Referral Response

**Planning Permit Application No. TP-2019-979-1
300 City Road Southbank VIC 3006**

Response to Waste Management Referral

Response to Urban Design Referral

Figure 2 - Approved scheme (LHS) vs current scheme (RHS) sectional

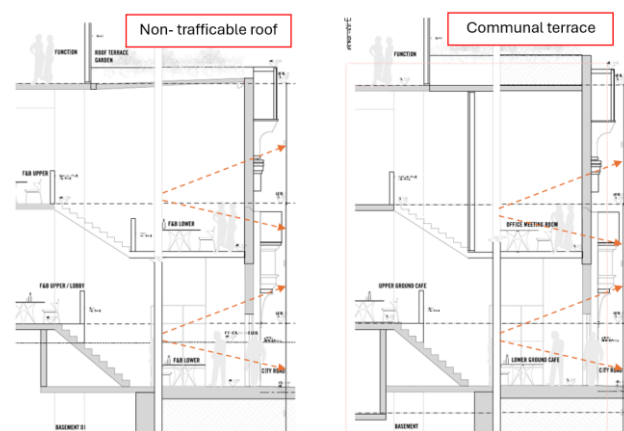
- Revised layout and spatial provision of the café / service area has reduced in size and prominence. There are concerns that the updated design will foster less interaction with the public realm and is not providing the same quality of offering. Refer Diagram 6 – Ground Floor Café.

- This inclusion of a café at ground floor should aim to promote continuity of activation along the streetscape and add activity to the public realm. The revised scheme presents a less enticing interface to the public and could be improved.

The current scheme will continue to provide appropriate integration / activation between the public realm and proposed ground floor café (see below figure).

The proposed office use on Level 1 will provide for passive surveillance opportunities to City Road.

In addition, the current scheme proposes a communal terrace on Level 2 (this area was previously non-trafficable) which will further promote surveillance over the public realm.

Figure 3 - Extract of cross-section showing split level ground floor

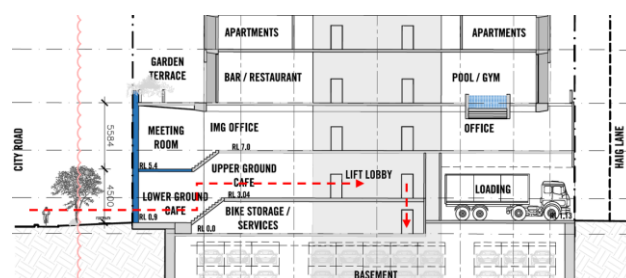
- Additionally, the toilets that previously serviced the café and were accessible from the ground floor appear to be now only accessible via residential Bike Storage Area.

- The proposed location is also less connected to back of house areas, which may present issues such as access to storage and waste areas.
- Further design consideration is required to ensure that genuine ground floor activation is facilitated by the hospitality offering and that it is supported by necessary functional requirements.

In respect to the ground floor toilets / connections to back of house (BOH) services, the ground floor is now proposed to be split into Lower Ground and Upper Ground levels.

The café patrons continue to have access to a DDA toilet on Upper Ground level adjacent to the lobby lounge (accessible via stairs and a DDA compliant lift platform).

Similarly, BOH services are accessible on the Upper Ground level with lifts down to the BOH services on Lower Ground level.
